March 20, 2020

**SOLICITATION ADDENDUM NO. #2**  
**RFP 19-0045**  
**2021 Roof Projects Design**

Roof Plan Diagrams

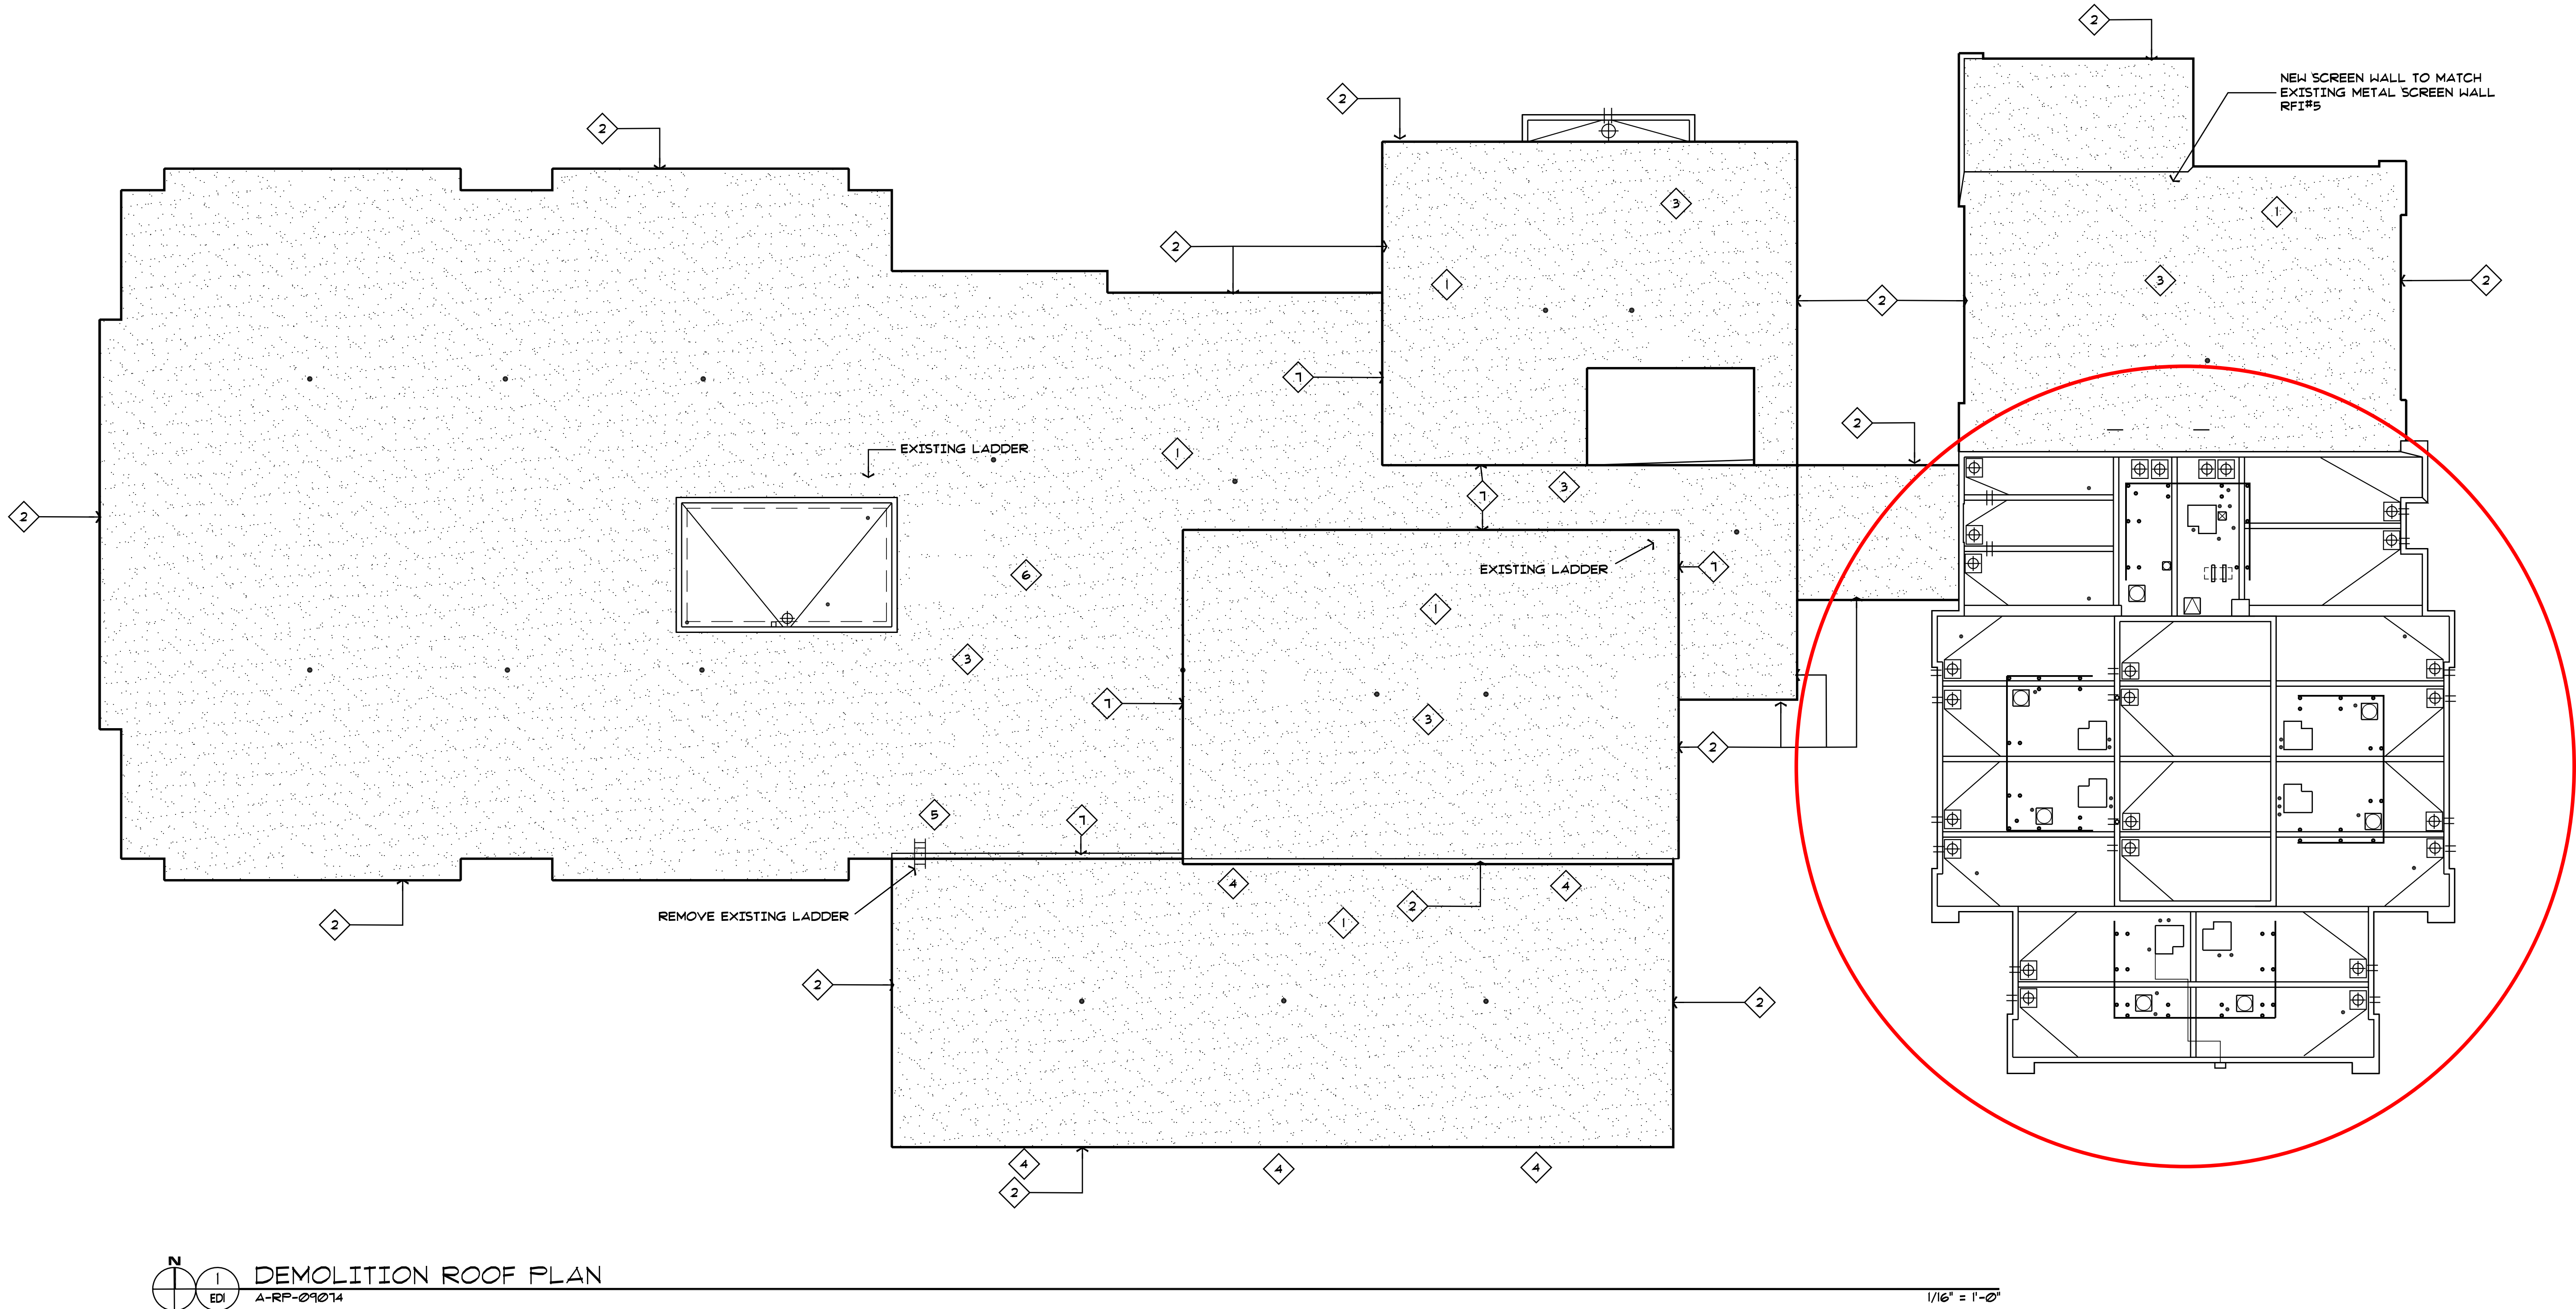
We are looking to re-roof the section circled.

DEMOLITION ROOF PLAN  
A-RP-09014

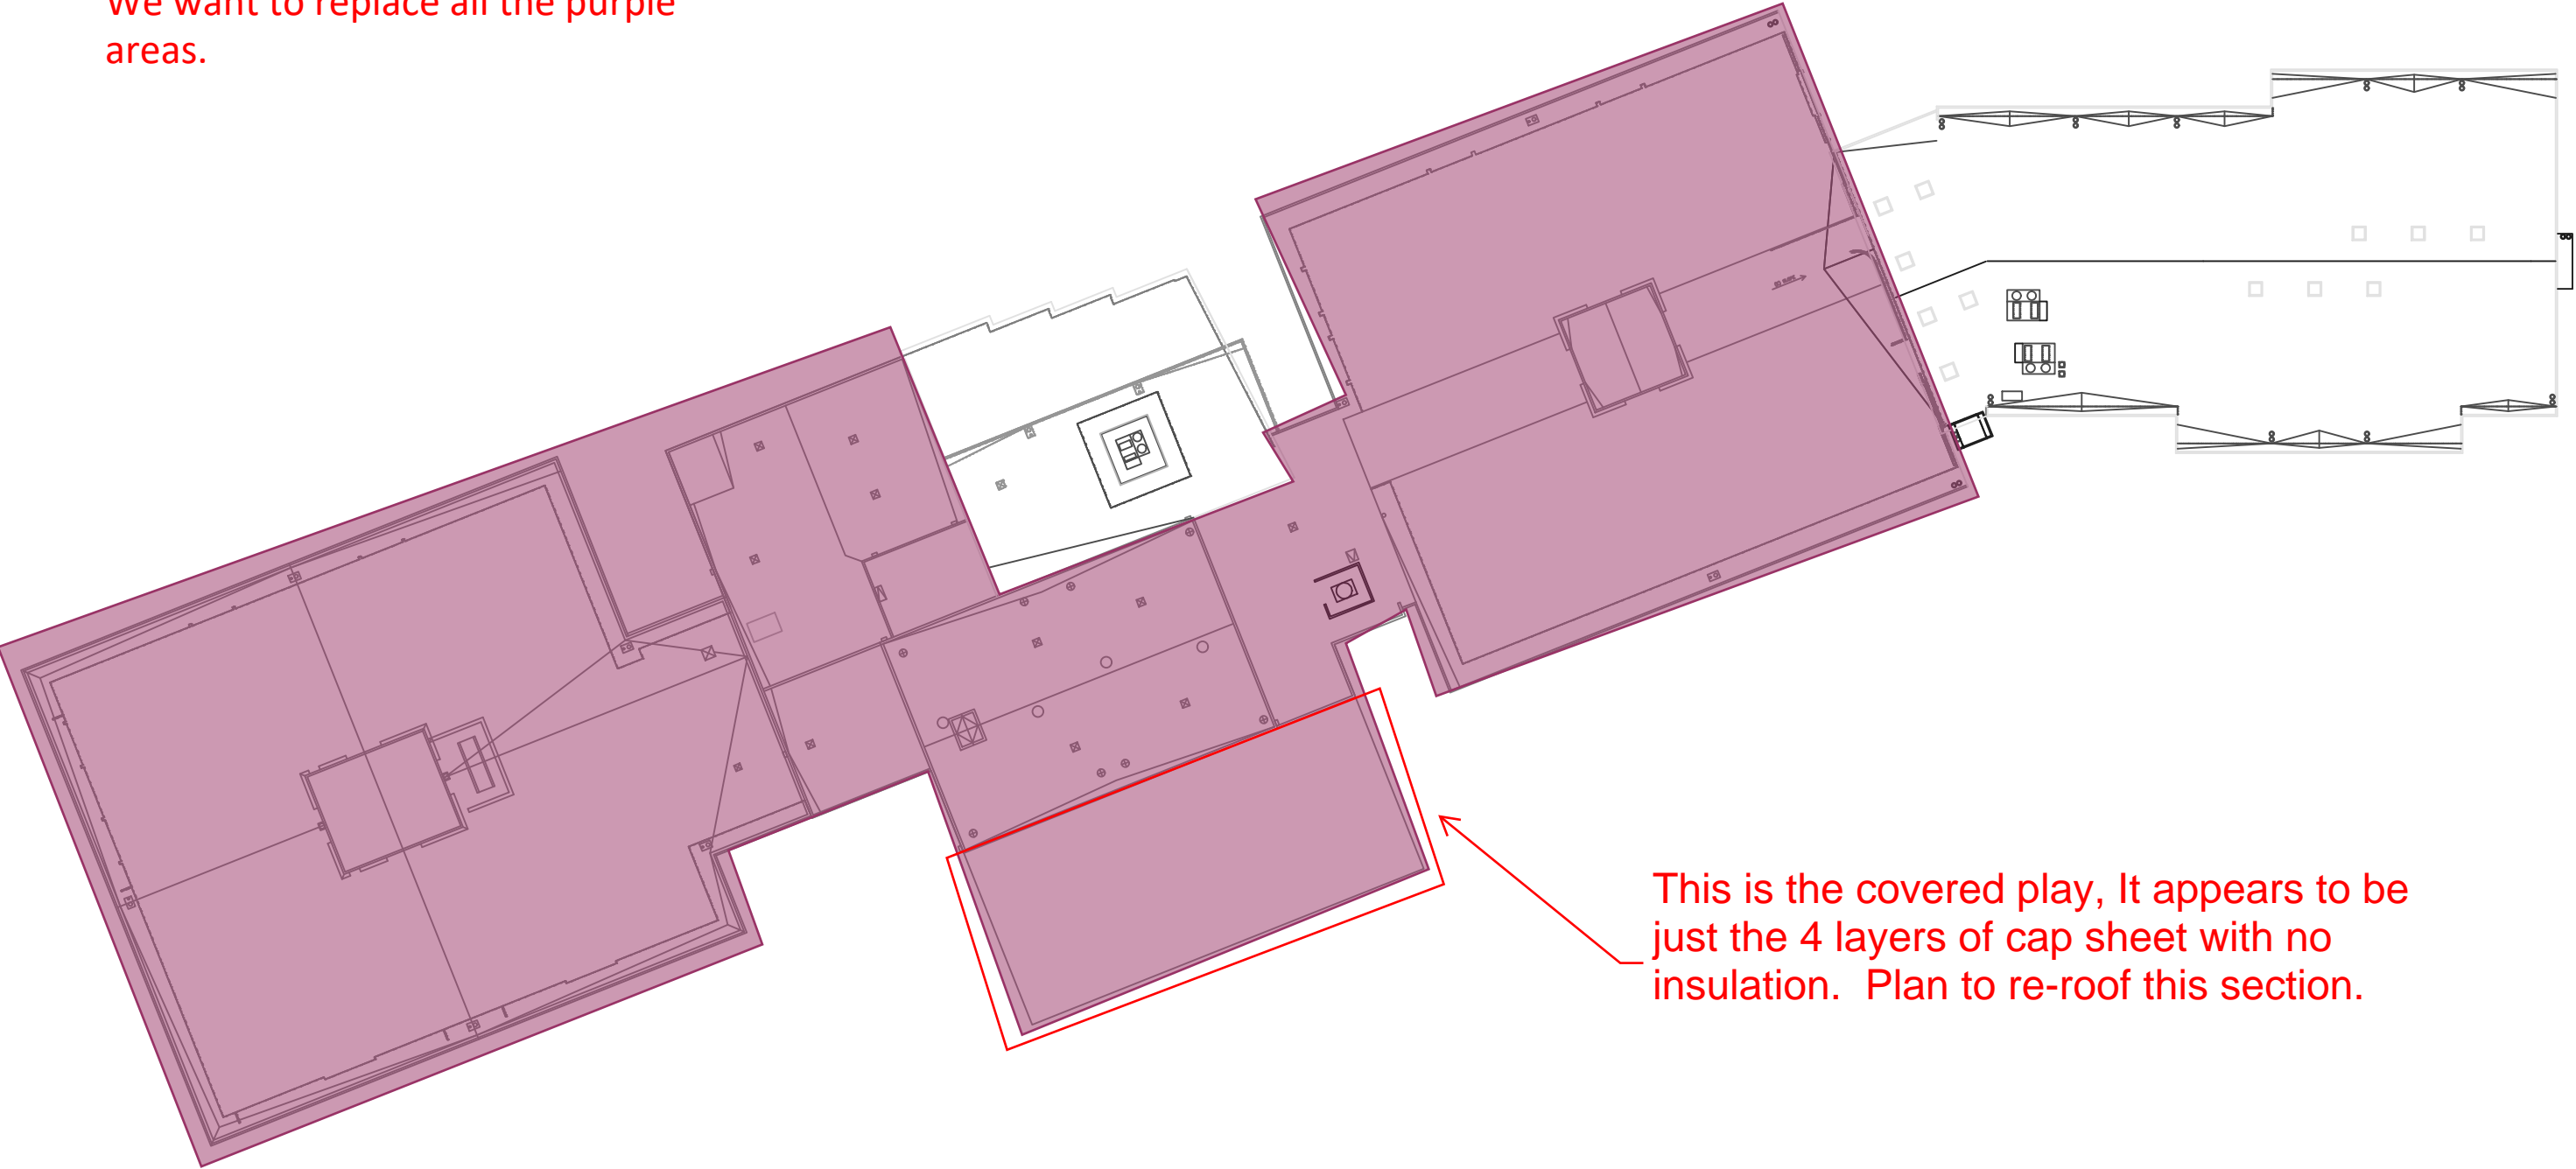
We want to replace all the purple areas.

**1 ROOF PLAN**  
SCALE: 1/16"=1'-0"

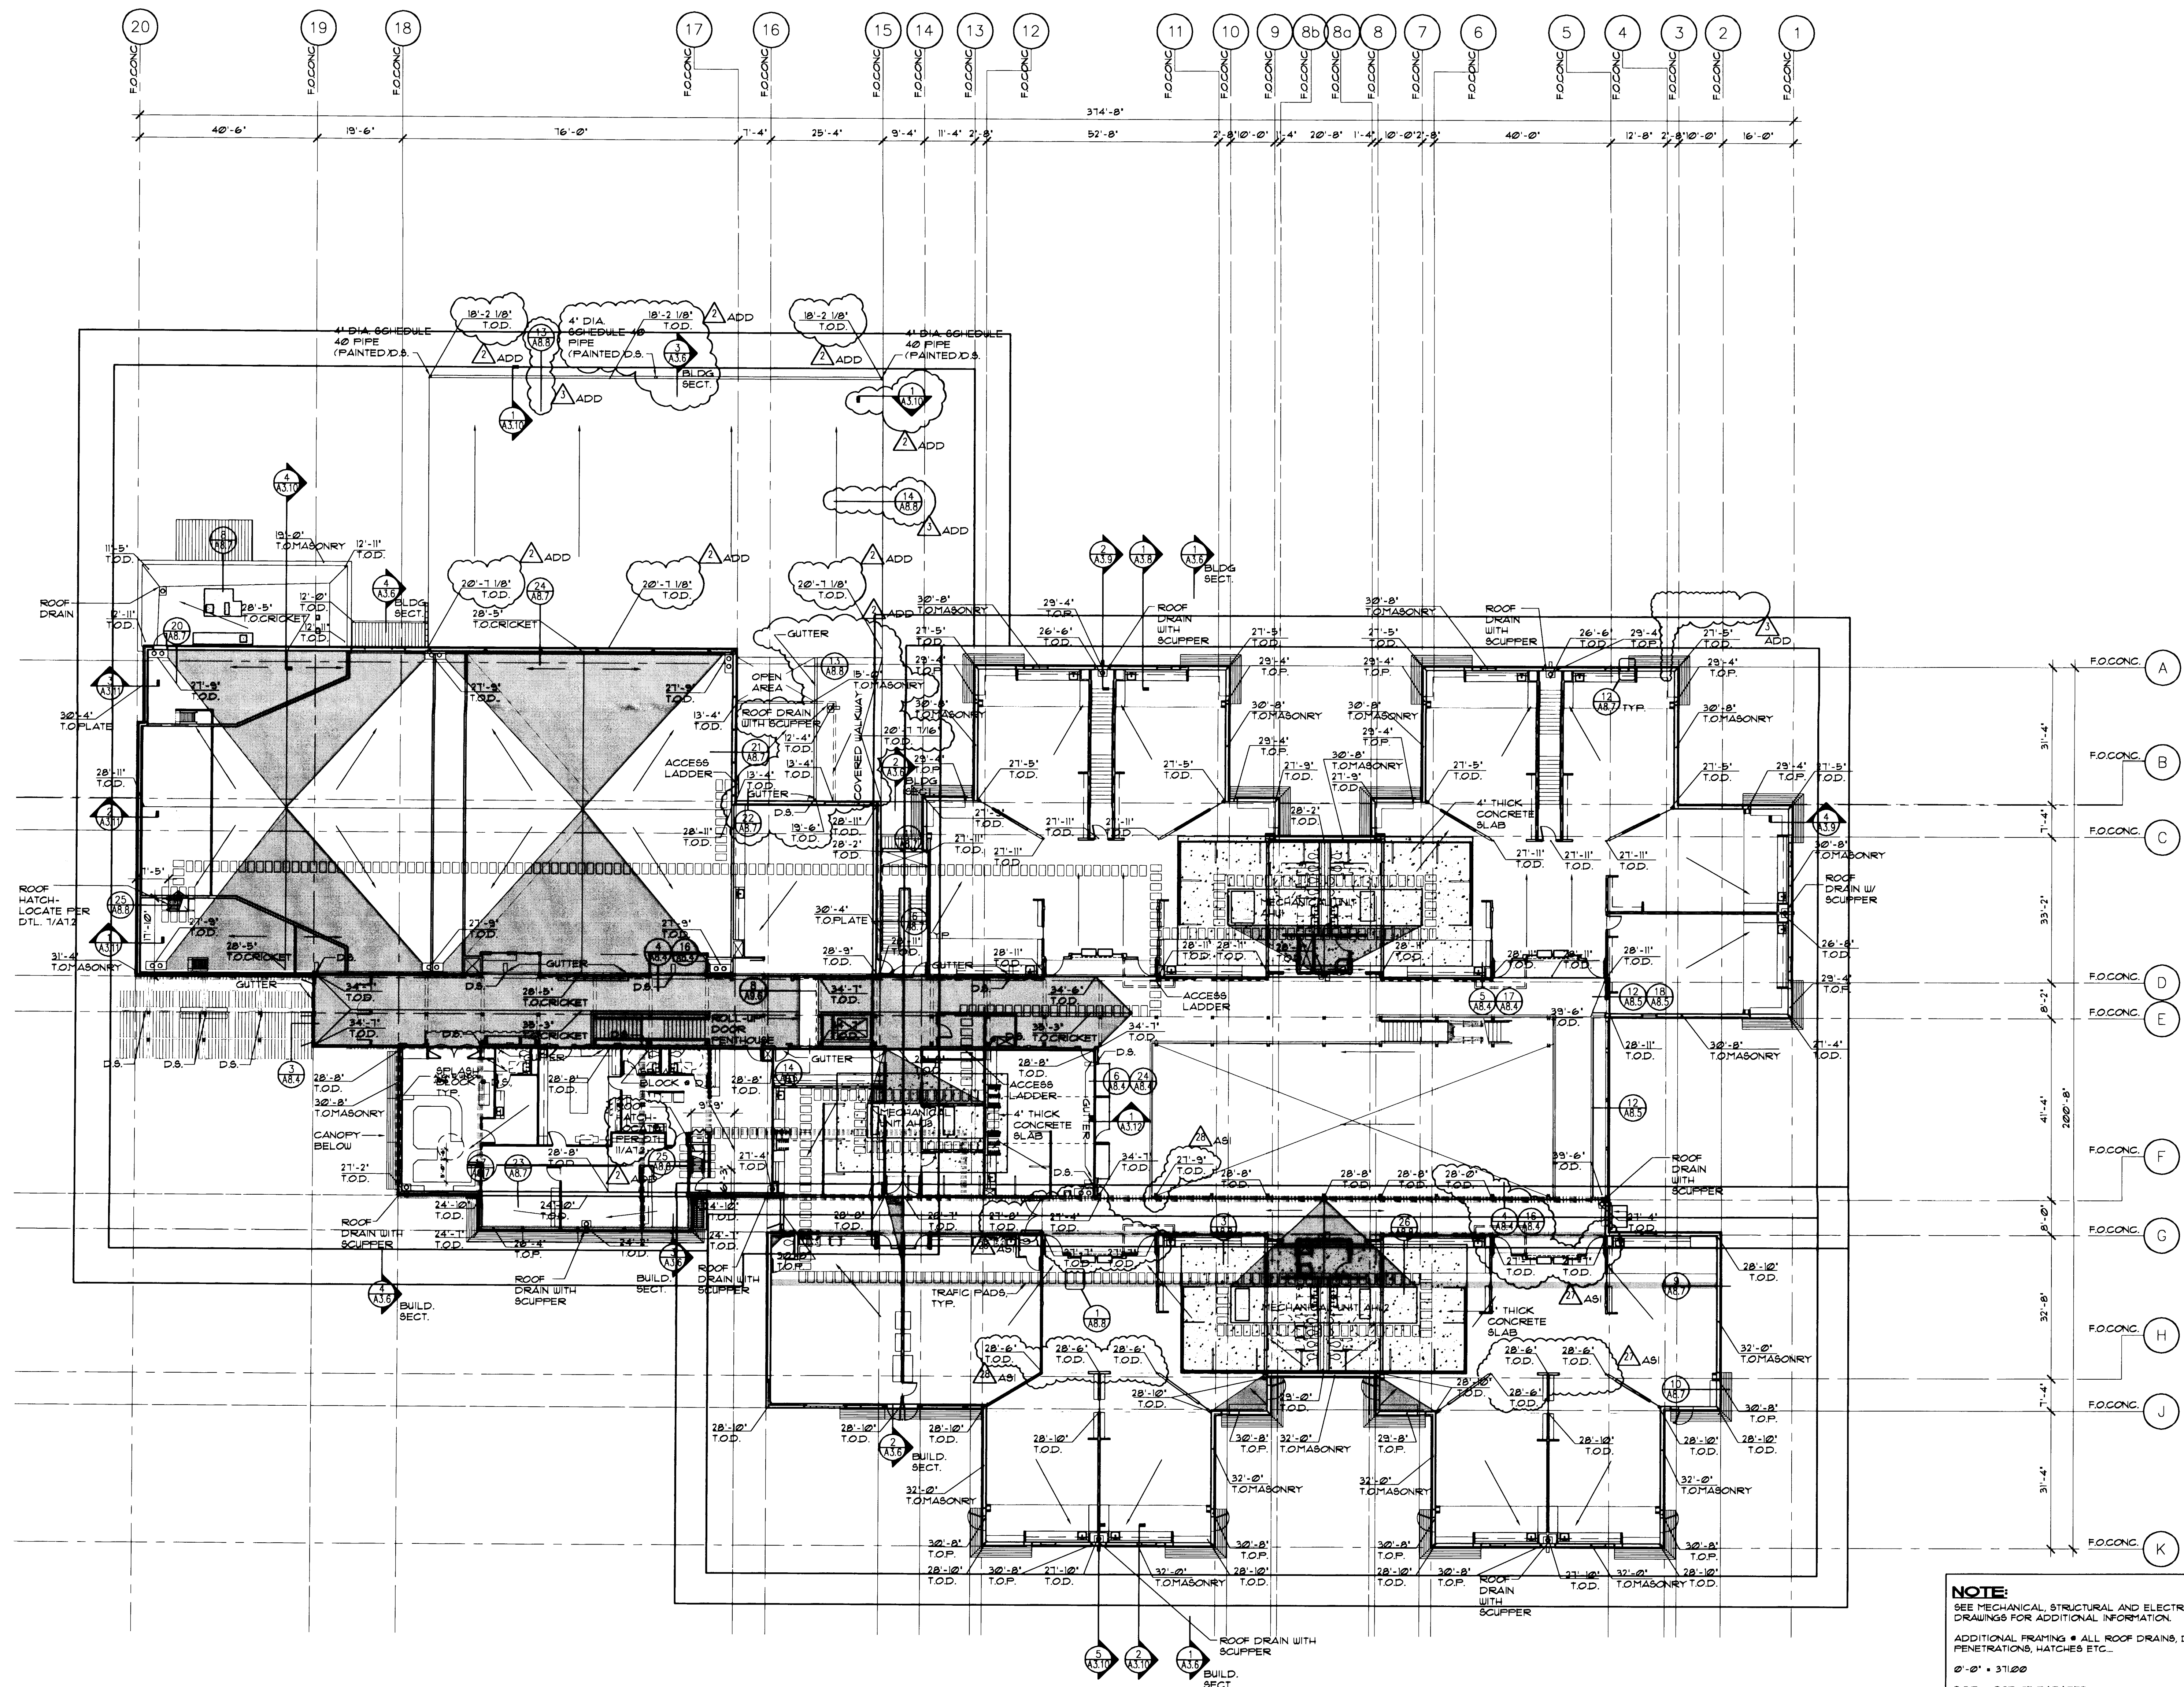
This is the covered play, It appears to be just the 4 layers of cap sheet with no insulation. Plan to re-roof this section.

Roof Plan  
**A2.20**

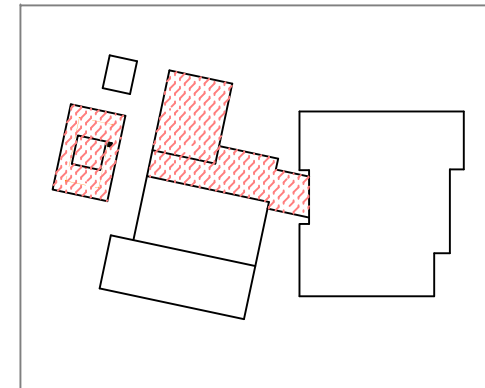
Not Neither of  
these  
buildings.
